Application for a Zoning Appeal

Project Name UST Multipurpose Arena
Address 2260 Summit Ave.

## MEMORANDUM

TO: Members of the St. Paul Planning Commission  
FROM: Advocates for Responsible Development, info@advocates4rd.org  
DATE: April 15, 2024

Fig. 2. A graphic illustration of the definition of the “bluffline”

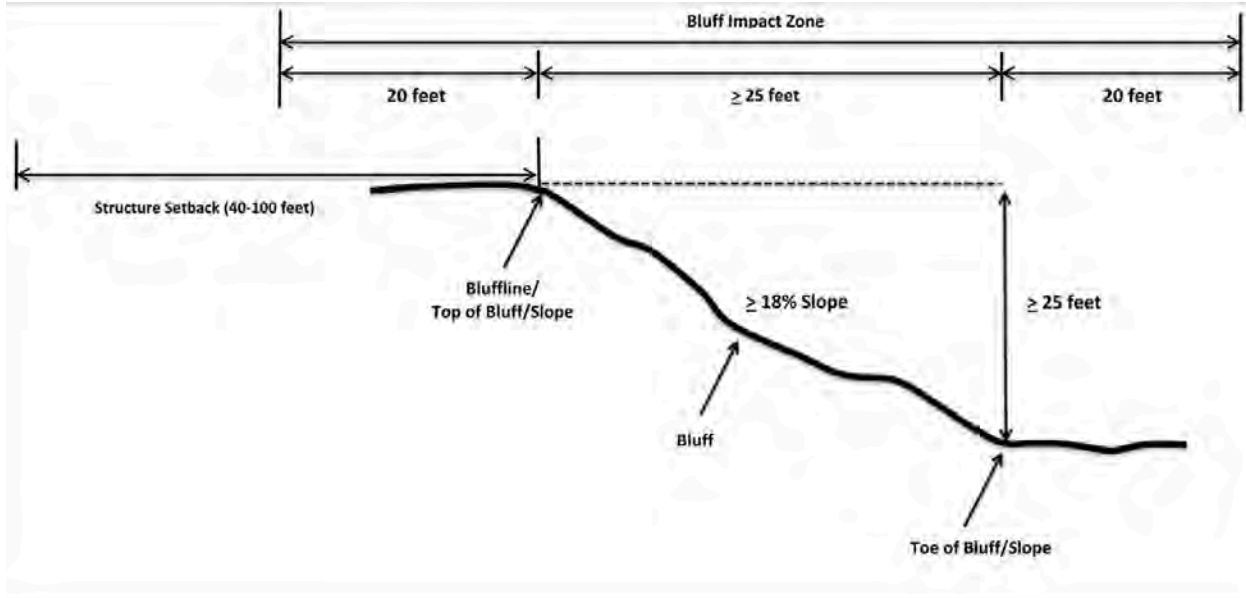
The MRCCA rules provide that no development (including impervious surfaces) may exist within 40 feet of the bluffline. St. Paul Leg. Code § 68.402(b)(4) contains the same restriction. The definition of a bluffline is graphically illustrated in the City’s publication *Mississippi River Corridor Critical Area* (Nov. 18, 2021) at 245. See Fig. 2.

Fig. 3. This figure in St. Paul’s MRCCA Publication was taken from Minn. R. 6106.0050, Subp. 9. The grotto is circled.

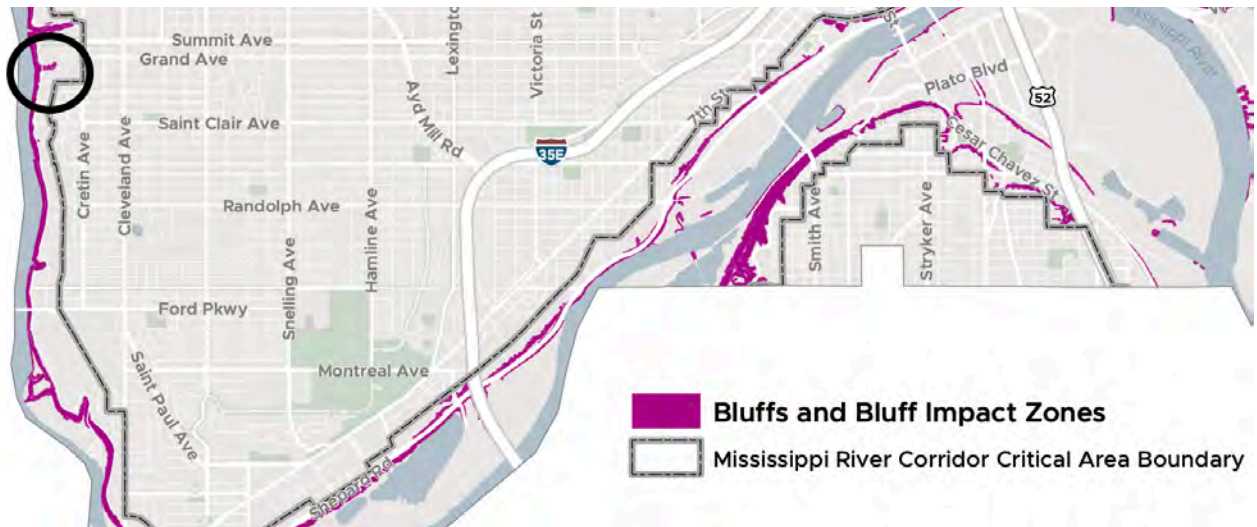
The same publication shows that the grotto is part of the river’s bluff area. See Fig. 3.

Fig. 4. The red arrows are approximately 40 feet long. The blue line is the bluffline.

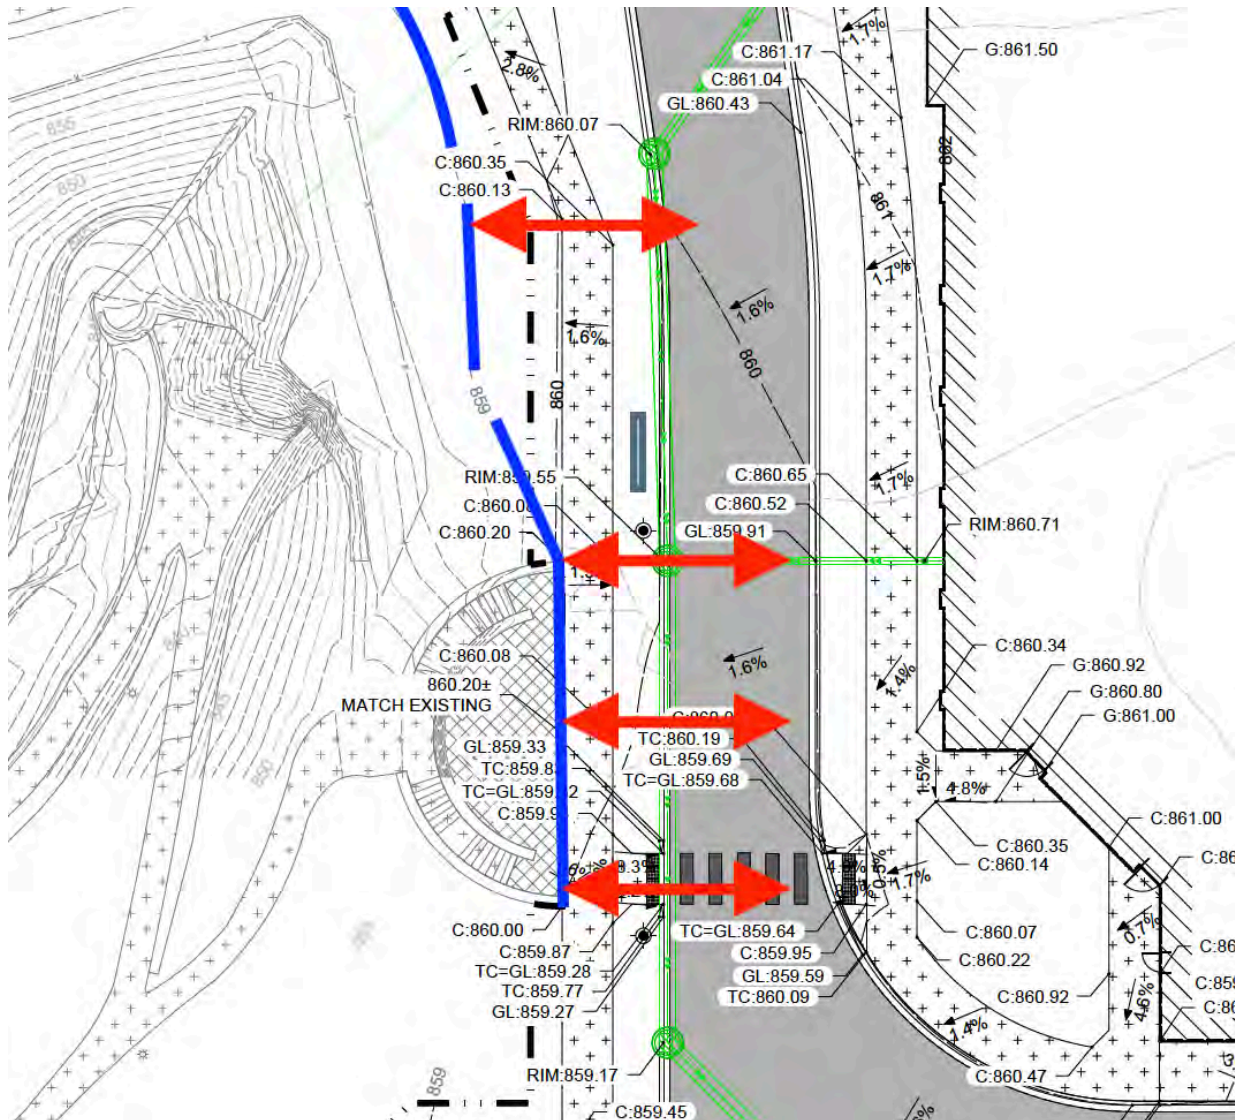
A specific area of concern is a ravine extending east from the river called the grotto. The grotto runs under the Mississippi River Boulevard and into the South Campus. The arena would be located just 40 feet from the bluffline of the grotto. By extension, this is also the bluffline of the river itself, and is specifically included in the mapping of the bluffs of the Mississippi River. To state it another way, the river bluff is located a little over about 40 feet west of the arena’s

western wall, and is located at approximately the midpoint of that wall. There is just no possible way to redirect the groundwater around the arena and have it flow in a natural way toward the grotto and the river. Concentrating the water (e.g., running it through a pipe) would cause massive erosion wherever the pipe ends. At the same time, the lack of groundwater will dry the soil, kill the vegetation, and result in erosion from rainfall.

The site plan shows that UST plans extensive development above and below ground adjacent to the bluff. Above ground, the site plan includes a two-way roadway with parking lane and a sidewalk within the 40-foot zone next to the bluffline. That leaves no permeable surface for rainwater to fall and soak into the ground, rather than running into a gutter and being transported elsewhere by pipe. Fig. 4. Unfortunately, the site plan is consistent with UST's plan in its

Fig. 7. Source: *Mississippi River Corridor Critical Area*, adopted Nov. 18, 2021 (City of St. Paul), at 263 (the Public River Corridor View in the corner was identified by Minneapolis).

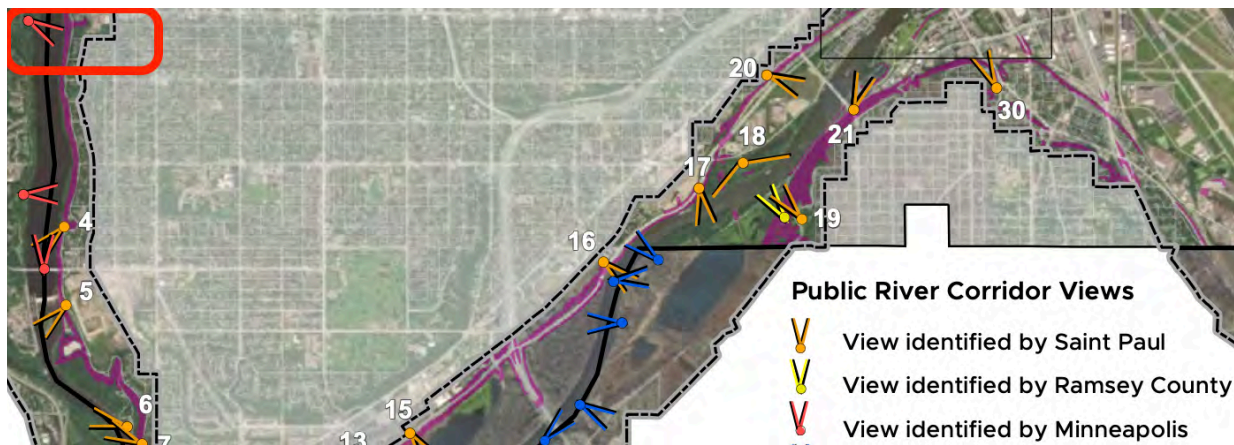
The new arena would dominate sightlines from the Mississippi River, presenting its gray western facade to those who would otherwise be enjoying the river’s wildness. Fig. 6. The City’s MRCCA Publication identifies the scenic overlook at East 36th Street and West River Boulevard in Minneapolis (Fig. 7, upper left corner) as a Public River Corridor View, and it looks directly at the arena site. The arena would be a dominating presence when viewed across the Mississippi River. At 76 feet tall, the arena would be taller than mature trees — but there will be no mature trees growing near the arena. The trees shown in UST’s rendering in Figure 6 would have no place to grow because the surface west of the arena is nearly 100% impervious. Any mature trees west of the arena grow from a lower part of the bluff, 40 feet below the blufftop perch of the arena. They would not screen the arena from the river.

While St. Paul already has some other tall buildings that soar over the riverside treetops and negatively impact the public river views, these are currently considered the results of poor city planning allowed by prioritizing private development over public enjoyment of the river’s wild beauty. They would not have been permitted under the City’s current codes, and neither should the UST arena. The Planning Commission should reject the site plan due to its interference with public river views.
